Extended Power baseline proposal

v260

Goal

Replace Figure 33-18

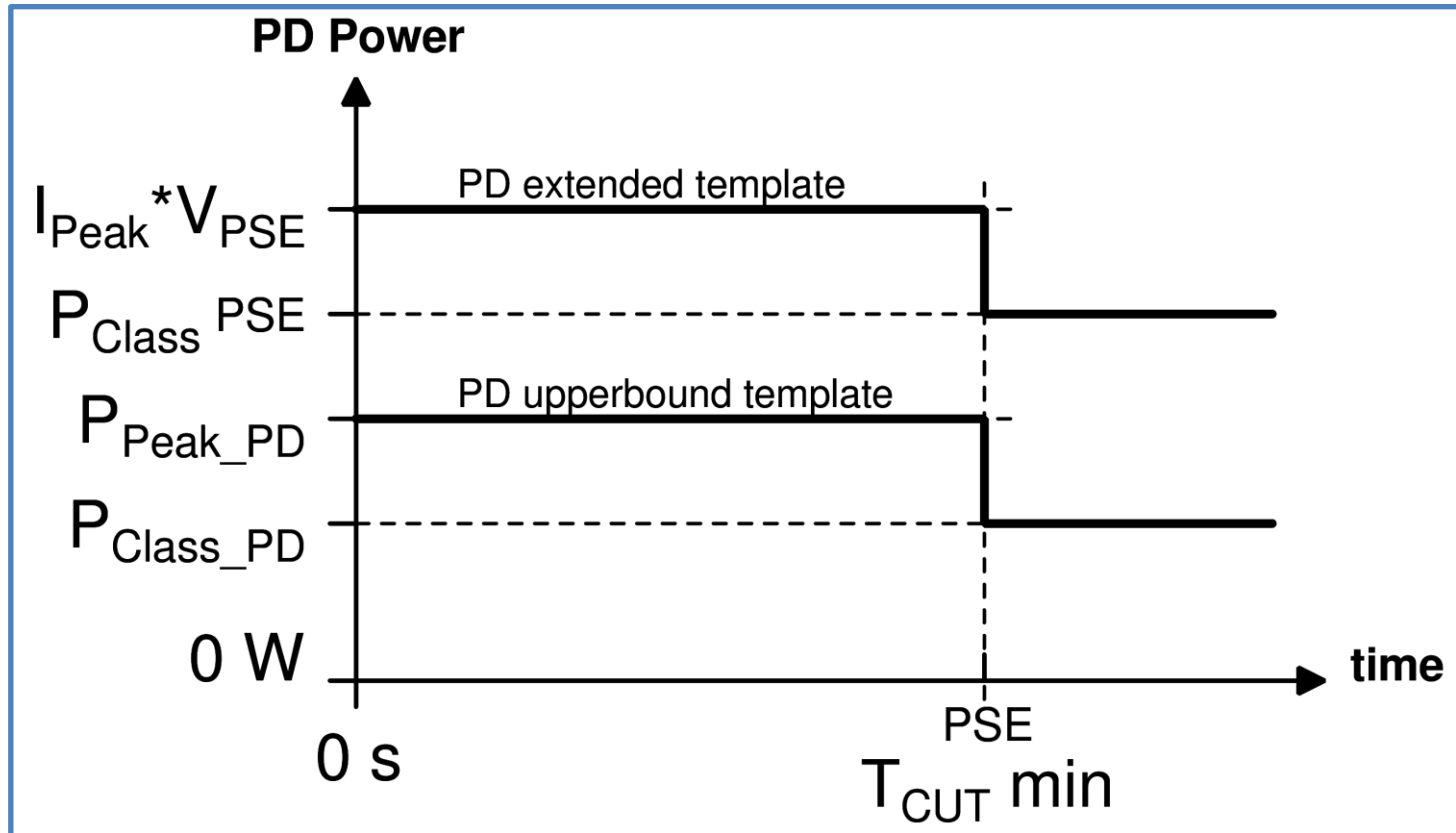
Info: The extended template is based on PSE PI parameters. At $R_{chan} = R_{ch}$ the extended and upperbound template lines are fully overlapping.

Replace:

Under normal operating conditions when there are no transients applied at the PD PI, the PD shall operate below the PD upperbound template defined in Figure 33–18.

Clarification: this text & figure do not allow the PD the exceed the upperbound template unconditionally. The condition is that the PSE shall not be caused to source more than P_{class} . This restriction is handled in section 33.3.7.2.

By:

Under normal operating conditions when there are no transients applied at the PD PI, Type 3 and Type 4 PDs that observed 4 classification events and presented a Class 6, 7 or 8 signature, or observed 5 classification events and presented a Class 8 signature shall operate below the PD extended template defined in Figure 33-18. Type 1 and Type 2 PDs, Type 3 and Type 4 PDs in Class 5 or 7, or PDs that cannot guarantee that the PSE will source less than P_{Class} shall operate below the PD upperbound template defined in Figure 33-18.

The PD extended template in Figure 33-18, P_{PDET} , is described by Equation (33-xx):

$$P_{PDET}(t) = \left\{ \begin{array}{l} I_{Peak} \times V_{PSE} \text{ for } (0 \leq t \leq T_{cut \text{ min}}) \\ P_{Class} \text{ for } (T_{cut \text{ min}} \leq t) \end{array} \right\}^W$$
